## General Information

Powertrain Power Distribution Module (PTPDM) protects circuits to the engine, transmission, and exhaust aftertreatment systems. This bulletin provides an alternative PTPDM mounting location that helps to reduce stress and vibrations that can be transmitted to the fuses and relays mounted in the PTPDM. This new bracket helps to reduce the risk of cracked fuses located in the PTPDM.

**Freightliner  
Service Bulletin**

**Fig. 4, New Powertrain Power Distribution Module (PTPDM) Bracket Installation**

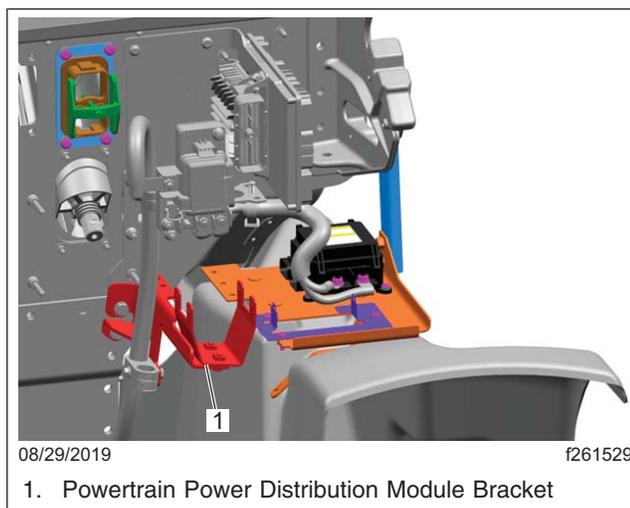
7. Attach the PTPDM bracket on the cab, using the previously removed bolts. Torque the bolts to 33 lbf-ft (44 N·m). See [Fig. 4](#).

**Fig. 5, Powertrain Power Distribution Module (PTPDM) Wiring Harness**

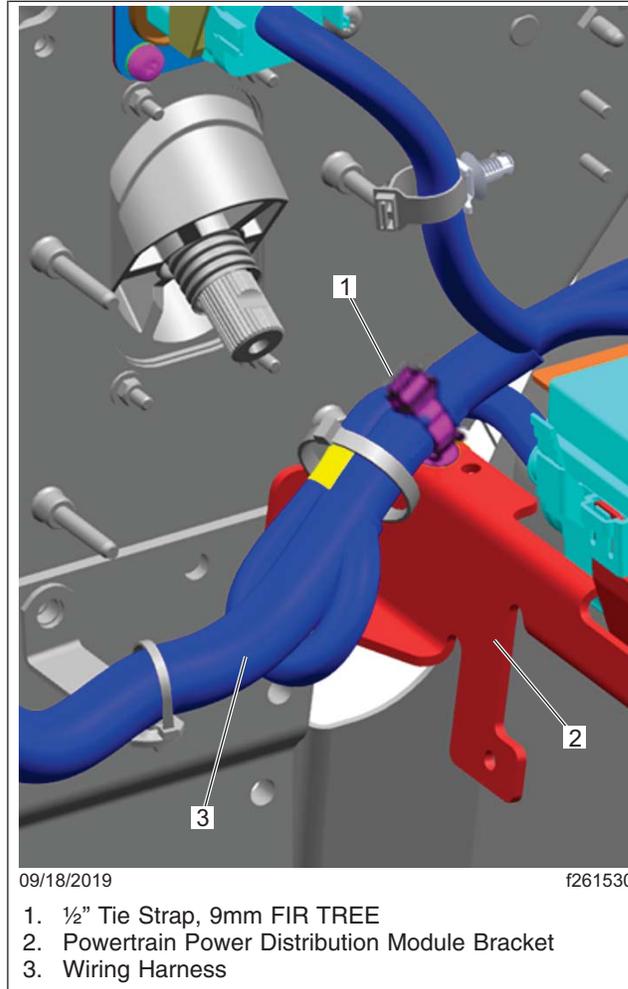
8. Position the PTPDM wiring harness, as needed, so that it exits the PTPDM housing horizontally, see [Fig. 5](#). Position the rubber grommet back into PTPDM housing.

**Fig. 7, Checking for Clearance**

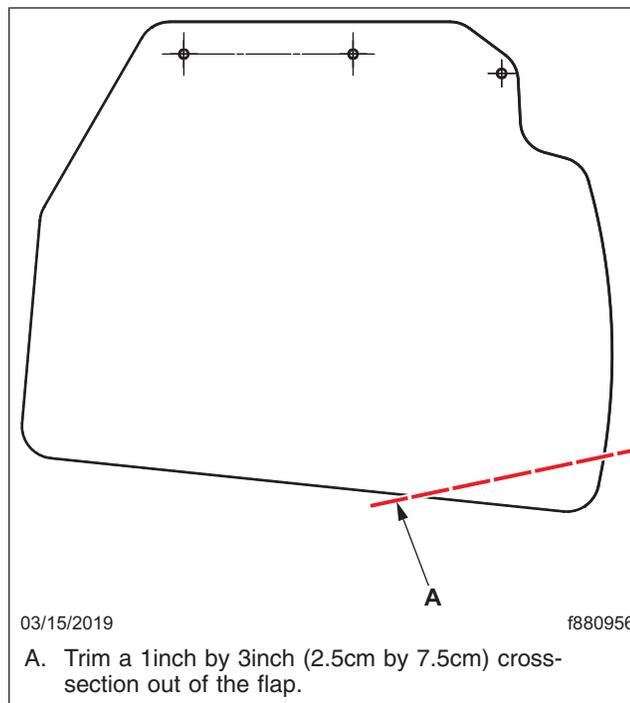
13. Close the hood and check for proper clearance between PTPDM and flap. If there is insufficient clearance, trim a 1inch by 3inch (2.5cm by 7.5cm) cross-section out of the flap. See [Fig. 7](#).

A. Trim a 1inch by 3inch (2.5cm by 7.5cm) cross-section out of the flap.
